16198A-01

Modification Available Performance Enhancement Service Note

16198A Bottom Electrode SMD Test Fixture

The screws which fix the DUT cover and PC board strip out

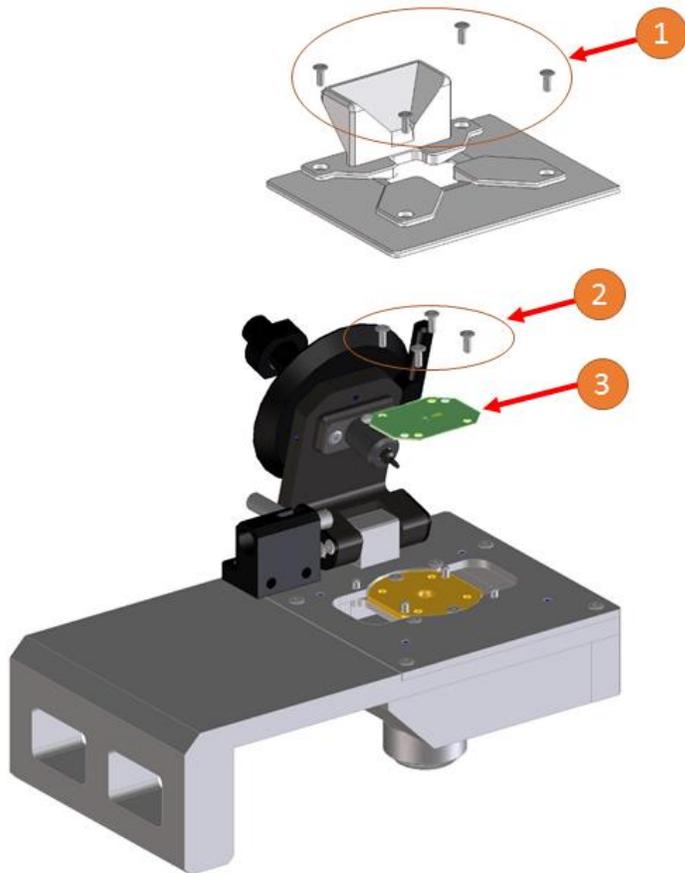
The hole of screws which fix the DUT cover and PC board may strip out. (four screws of No.1 and No .2 in the figure) while installing

Screw has been change to one with the stronger and bigger hole to avoid them stripping out. Due to the change of screw, the DUT cover and the Hex-bit for the torque driver are also changed.

Replace 8 screws and DUT cover with new ones.
